SUNDRY NOTICES AND REPORTS ON WELLS
Do not use this form for proposals to drill or to re-enter an abandoned well. Use form 3160-3 (APD) for such proposals.

1. Type of Well <input checked="" type="checkbox"/> Oil Well <input type="checkbox"/> Gas Well <input type="checkbox"/> Other	2. Name of Operator CIMAREX ENERGY COMPANY Contact: PAULA BRUNSON E-Mail: pbrunson@cimarex.com	5. Lease Serial No. NMMO1085	6. If Indian, Allottee or Tribe Name
3a. Address 600 N MARIENFELD STE 600 MIDLAND, TX 79701	3b. Phone No. (include area code) Ph: 432-571-7848	7. If Unit or CA/Agreement, Name and/or No. IRWIN 23-14 FEDERAL 4	8. Well Name and No. IRWIN 23-14 FEDERAL 4
4. Location of Well (Footage, Sec., T., R., M., or Survey Description) Sec 23 T19S R30E NENE 1300FNL 785FEL	9. API Well No. 30-015-39894	10. Field and Pool, or Exploratory HACKBERRY; BONE SPRING, NW	11. County or Parish, and State EDDY COUNTY, NM

Cimarex Energy respectfully requests the following changes to the APD:

**Cimarex Energy Company
Irwin 23-14 Federal 4
API 30-015-39894
T19S-R30E, Sec 23
February 11, 2013**

Internal Hydrostatic Test Graph

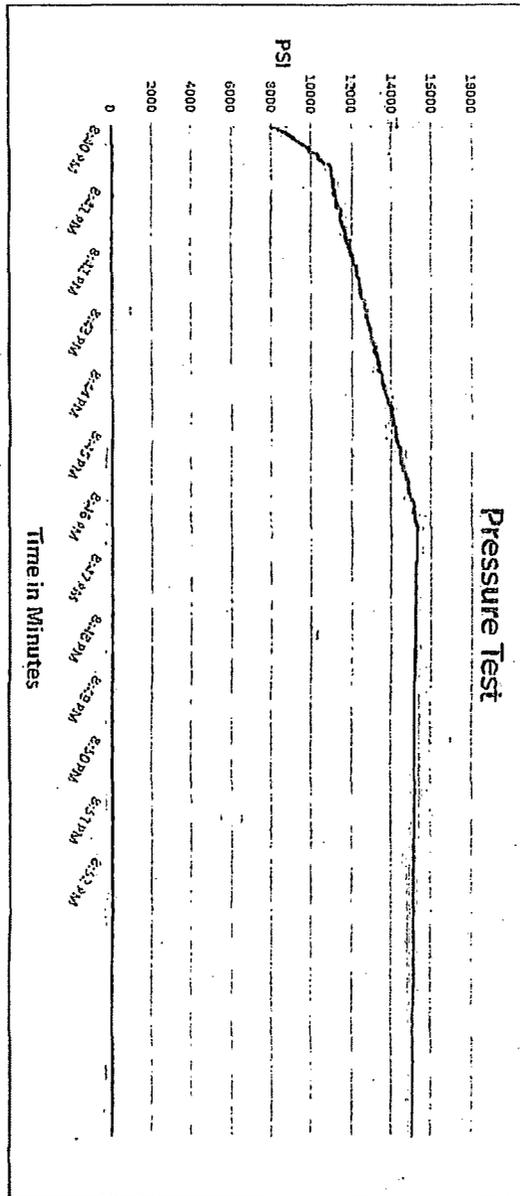
Cimarex Energy requests a variance to drill this well using a co-flex line between the BOP and choke manifold. Certification for proposed co-flex hose is attached. The hose is not required by the manufacturer to be anchored. In the event the specific hose is not available, one of equal or higher rating will be used.

Wait on cement (WOC) time for a primary cement job is to include the lead cement slurry due to potash and Capitan Reef.
2. Variance approved to use flex line from BOP to choke manifold. Check condition of flexible line from BOP to choke manifold, replace if exterior is damaged or if line fails test. Line to be as straight as possible with no hard bends and is to be anchored according to Manufacturer's requirements. The flexible hose can be exchanged with a hose of equal size and equal or greater pressure rating. **Anchor requirements, specification sheet and hydrostatic pressure test certification matching the hose in service, to be onsite for review.** If the BLM inspector questions the straightness of the hose, a BLM engineer will be contacted and will review in the field or via picture supplied by inspector to determine if changes are required (operator shall expect delays if this occurs).
